SERVICE NEWS

AUGUST, 1961

CORVAIRE REAR WHEEL BEARING REPLACEMENT

This article presents revised service procedures for replacement of 1961 Corvaire and Corvaire "95" rear wheel bearings.

Fig. 1—Rework of Press Plate J-5741

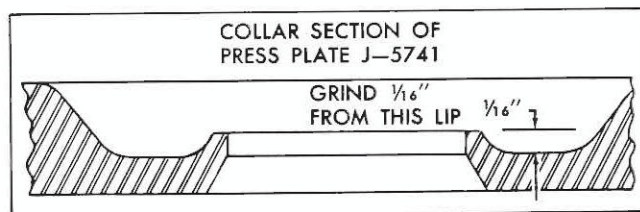
Due to a change in bearing puller ring design, effective in early 1961 Production, it will be necessary to rework press plate J-5741 for use in removal of rear wheel bearings on the later production

Corvaire 500, 700 and 900 Series vehicles. Rework of tool J-5741 will be performed as illustrated in Figure 1. When J-5741 has been reworked, it will then be the same as press plate J-8619-1 which supersedes it in the Kent-Moore tool line.

Fig. 3—1961 Late Production Wheel Bearings

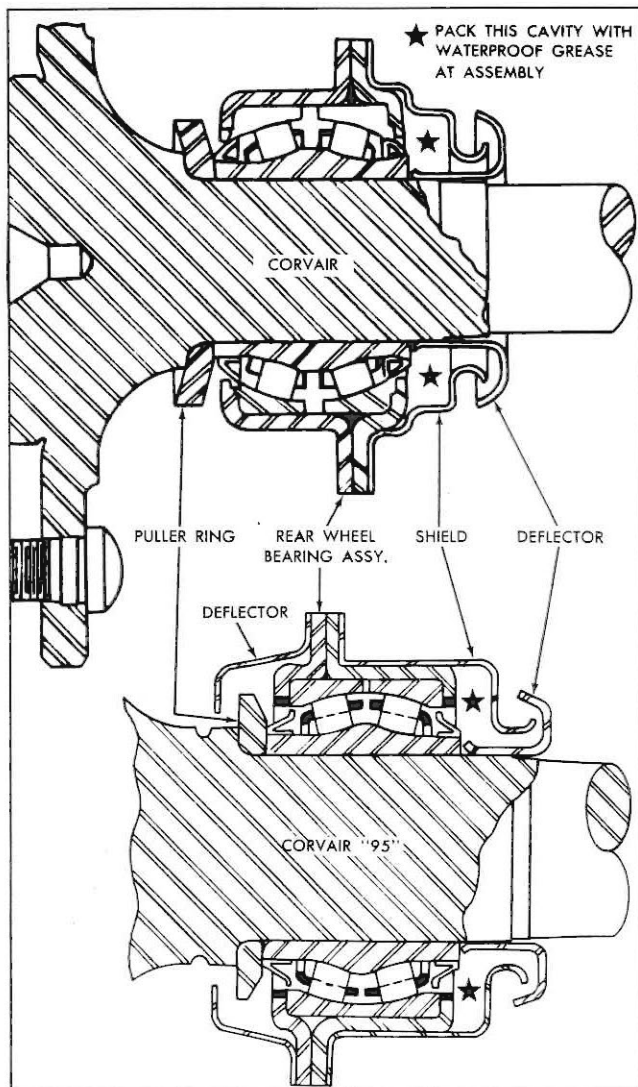
3. Before installing bearing shield on bearing assembly, pack cavity between bearing race and shield (Fig. 3) with high melting point wheel bearing grease. Press shield on bearing using suitable length of 2½ I.D. pipe or steel tubing. Bend over tangs on shield.
4. Install deflector on axle shaft, with deflector collar contacting bearing inner race.

Fig. 5—Passenger Car Speedometer Cable

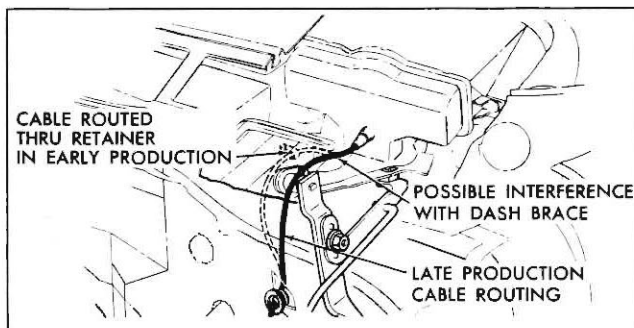
The speedometer cable routing utilized on early 1961 Passenger Cars can cause cable bind resulting in speedometer drive noise and needle oscillation. This is due to a heavy interference condition that sometimes exists between the speedometer cable and the instrument panel to dash brace. On early production manual transmission equipped vehicles, this condition would be aggravated by the critical bend introduced in the cable as the result of its routing through a plastic retainer on the top of the dash brace. (Fig. 5).

To reduce cable interference at the dash brace and minimize drive shaft bind, a revised speedometer cable routing (Fig. 5) is being used in late production vehicles. To insure a free routing of the speedometer cable in early production vehicles, perform the following:

1. On all vehicles, remove plastic retainer securing the speedometer cable to the dash brace.

2. On manual transmission vehicles, route the cable over the top of the clutch pedal shaft housing (located between the pedal arm and dash brace). See Figure 5.
3. If heavy interference exists between the speedometer cable and dash brace, the brace may be realigned to minimize this interference, as follows:

Fig. 7—Air Vent Control Cable

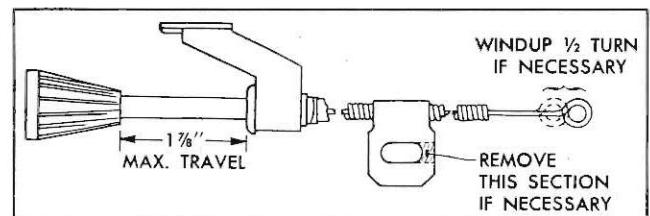
On some early 1961 passenger cars, an objectionable rattle may occur when the right air vent control knob is pulled out to its full travel limit. This rattle is due to excessive control wire travel, that allows the knob and shaft assembly to be pulled more than $1\frac{7}{8}$ " out of its instrument panel guide bracket. To reduce knob travel, proceed as follows:

1. Remove the right cowl side kick pad.
2. Reposition the vent cable slotted clip to relocate the conduit relative to its body attaching point. If necessary, the section of the clip mounting tab, shown as a shaded area in

Figure 7, may be removed to provide additional adjustment.

3. If knob travel still exceeds $1\frac{7}{8}$ " after completion of step #2; use a pair of long nose pliers to wind an additional $\frac{1}{2}$ turn of control wire into the end loop.

Fig. 9—Compressing Division Channel Rivets

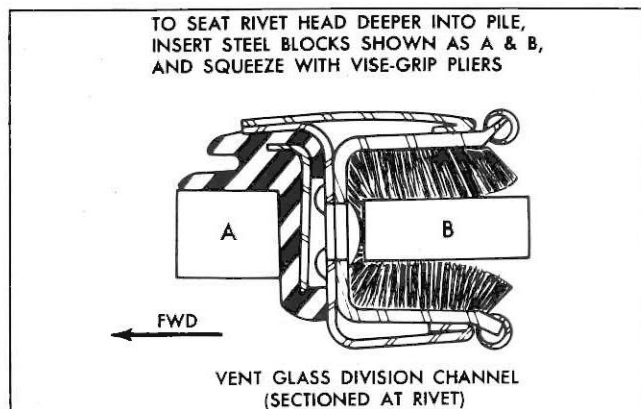
To insure against breakage of front door glass on Corvaire "95" Series vehicles built prior to May 1, 1961, inspect the ventilator glass division channel for presence of rivet heads protruding into the main glass run channel. If rivet heads in the

channel protrude beyond the pile fabric which surrounds them, it could cause the glass to break in the lower front corner of the window.

In Production, a design change in the division channel, effective with vehicles serial F111121 and S126580, averts the above problem on late production vehicles.

If this problem is encountered on early production vehicles, the rivet heads in the glass division channel should be recessed below the level of the pile. To compress the rivets, vise-grip pliers can be used to bear upon a pair of steel blocks placed as shown in Figure 9.

Fig. 10—Window Regulator Clutch Rework

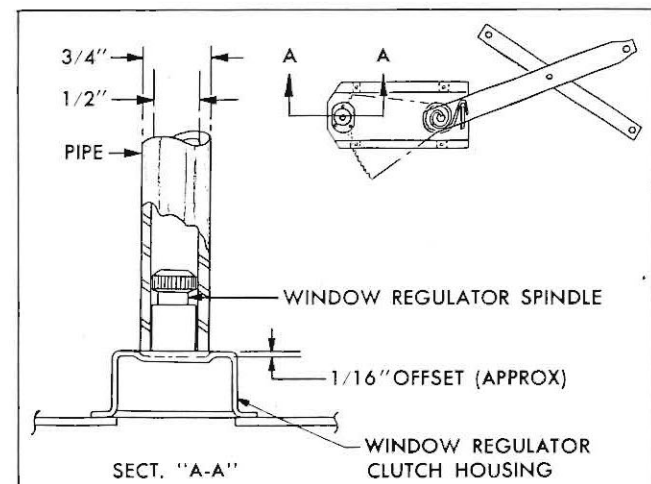
On 1961 Passenger Car and Corvaire vehicles, if a door or quarter window "works down" or drops slightly from the full "up" position, this condition will, in most cases, be caused by slippage within the window regulator clutch assembly. To correct

1. Remove window regulator control handle from spindle.
2. Using a suitable length of $\frac{1}{2}$ " pipe and a hammer, strike the regulator clutch housing to create a $\frac{1}{16}$ " offset in the spindle area of the housing, as shown in Figure 10.
